### National Committee on Uniform Traffic Control Devices

#### Signals Technical Committee Recommendations

Approved by the NCUTCD Council January 2008 & June 2008

*Figure 4E-1. Typical Pedestrian Signal Indications*

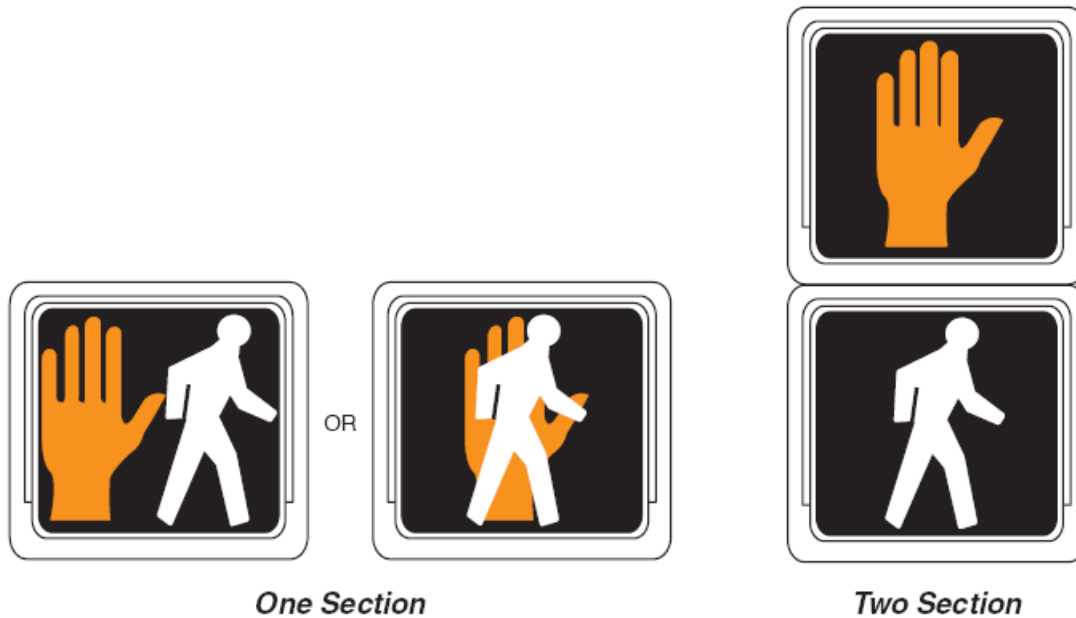
Need two additional *typicals* to show Countdown Pedestrian Signals

- Integrated countdown with in a "One Section" unit
- Separate CPS signal unit showing the appropriate position relative to the standard pedestrian unit

Figure 4E-2. Recommended Pushbutton Locations

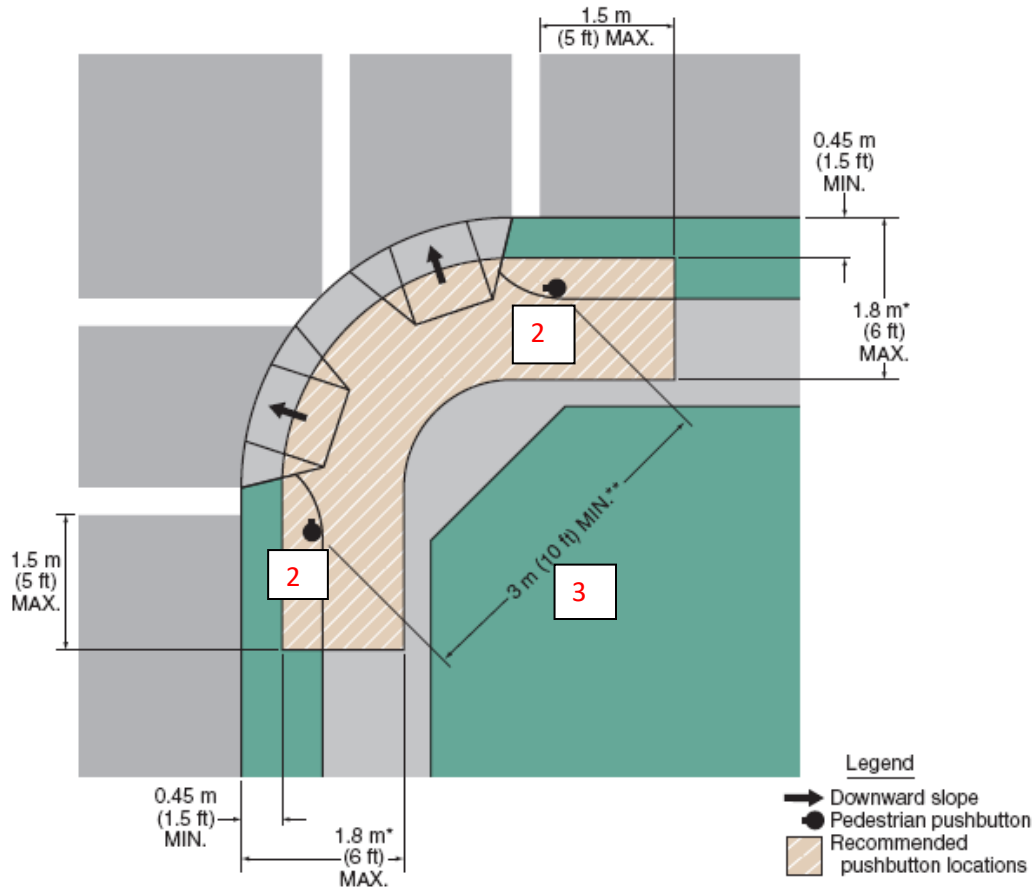
1. Change figure title to "Pushbutton Location Area"
2. Remove button symbol from the drawing as the button may be acceptably located throughout the shaded area.
3. Remove this dimension as it is between items that are to be removed.
4. Remove both of these asterisked notes, The practitioner who wishes to digress from the standard illustrated in the figure should see the full text of the section.
5. Add note that "Two pedestrian pushbuttons on a corner should be separated by 3m (10ft)."

6. Clean-up drawing to correct the following:
  - Make the drawing proportionally correct by
    - reduce size of ramp compared to crosswalk or increase the size of crosswalk;
    - reduce the shaded area away from the intersection, so that the distance is proportional to the width of the sidewalk;
  - Correct the orientation of the ramps to the street/crosswalk, so that the ramp is aligned to the crosswalk;
  - Endeavour to draw the figure in a way that strives to be "to scale", however, after doing that, the figure should be labeled "not to scale".
  - Since the ramps are adjacent to landscape/grass area, there is no need for flares next to the grass
7. Add detectable warnings to the ramps shown here and add a legend entry for the detectable warning.

Figure 4E-3. Typical Pushbutton Locations (Sheet 1 of 2)

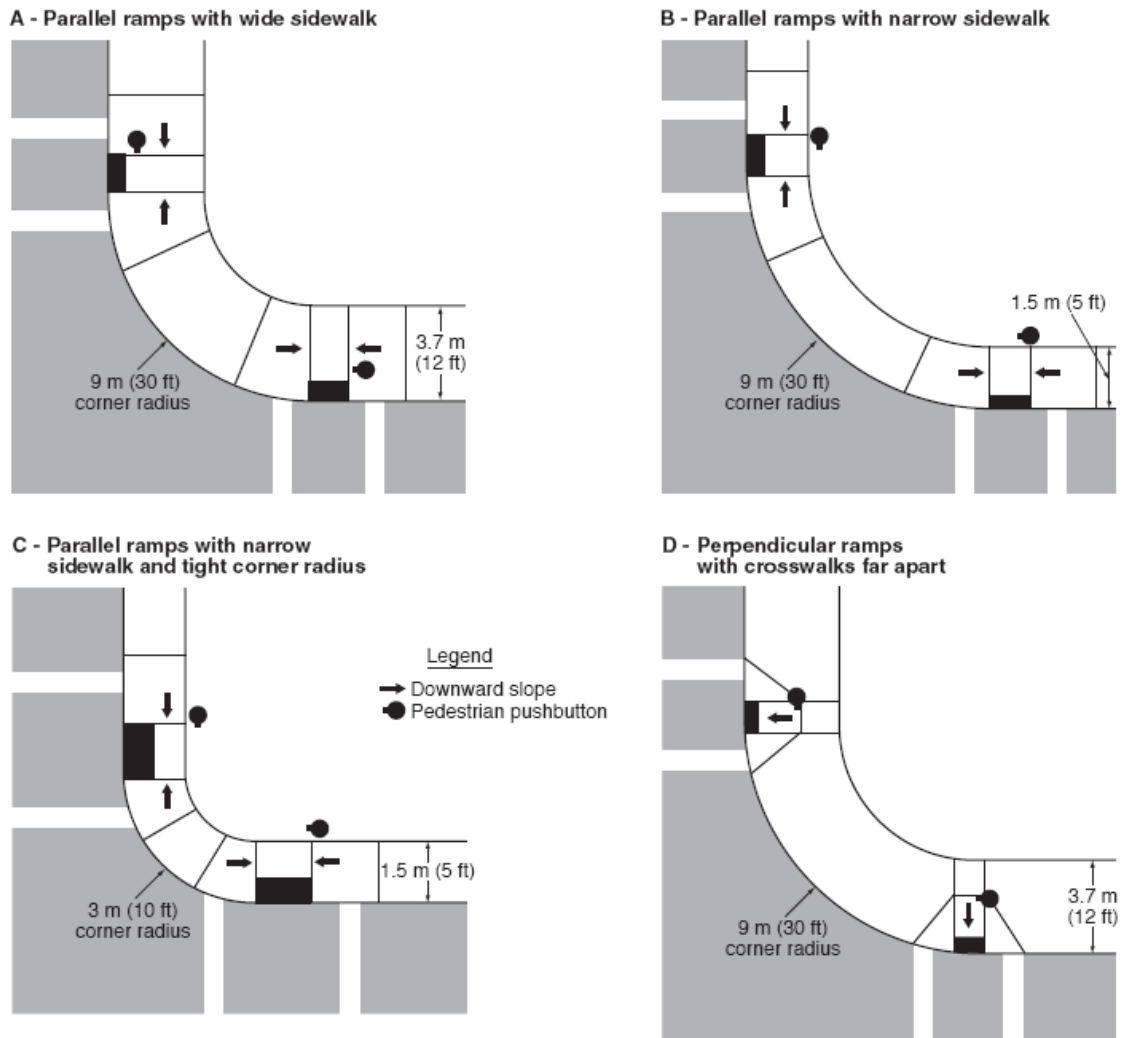
1. Add a legend for the detectable warning feature.
2. Shade the landing areas shown on the typical drawings and add a legend to explain the shading chosen.
3. Add "Not to Scale" note, while striving to provide the drawings more proportional.
4. Keep proportions as true as possible so that landing areas are "square" where not constrained by R-O-W or other issues.
5. These drawings are intended to describe the typical location to install a pedestrian pushbutton. They are not intended to be a guide for the design of the ramp.

Figure 4E-3. Typical Pushbutton Locations (Sheet 2 of 2)

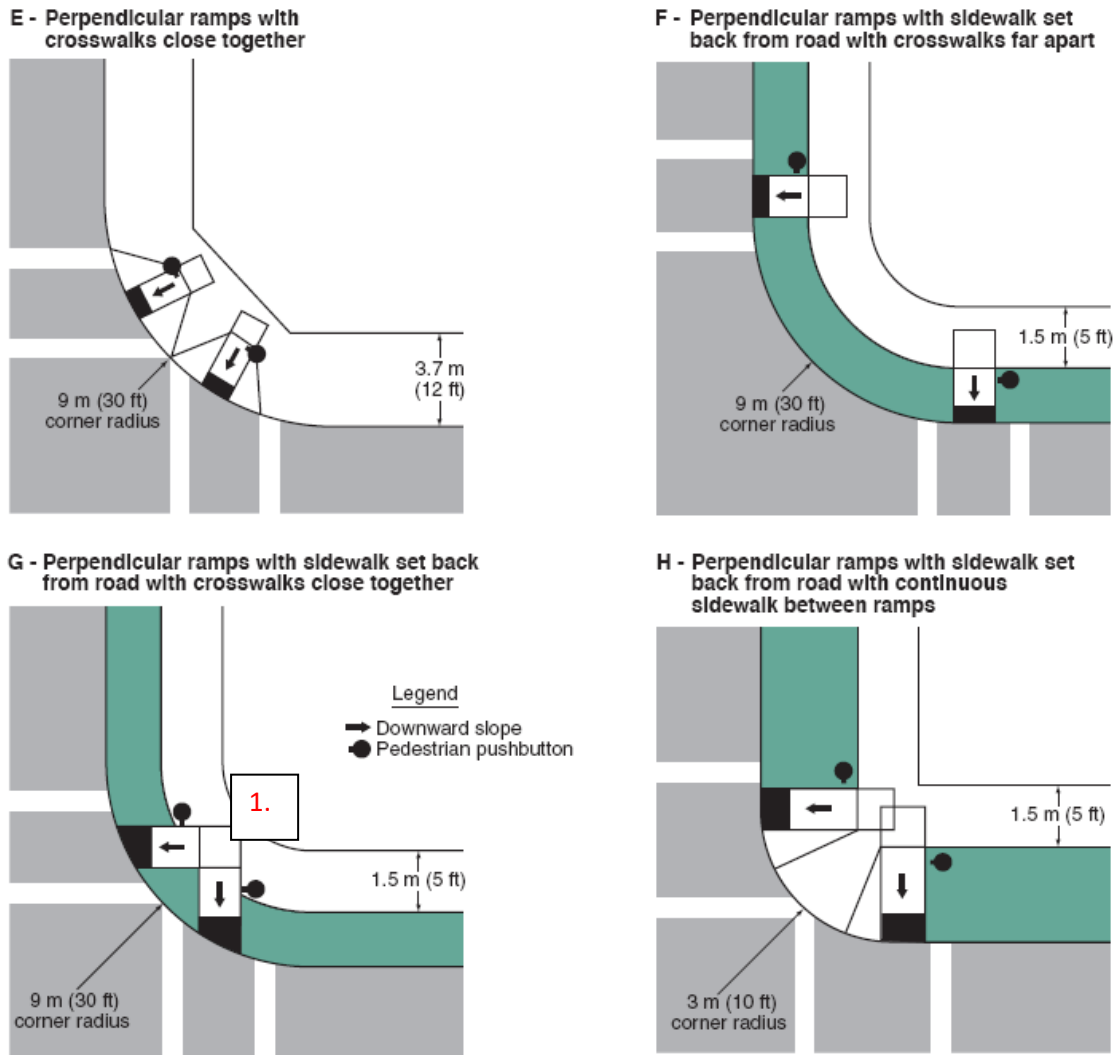
1. Please correct the design of the ramp and its detectable warning in typical "G".
  - a. The bottom of a ramp is required by ADAAG to be perpendicular with ramp slope, so all four (4) wheels of a wheelchair remain in contact with the surface as the user transitions between the ramp and the street.

- c. See Figure 4d on page 30 in an article in ITE Journal April 2005 "Developing Curb Ramp Designs Based on Curb Radius". This figure is very similar to the typical G of this figure.(This figure is shown on the next page)

2. Same comments as the sheet 1 of 2 for this figure (4E-3).
3. These drawings are intended to describe the typical location to install a pedestrian pushbutton. They are not intended to be a guide for the design of the ramp.
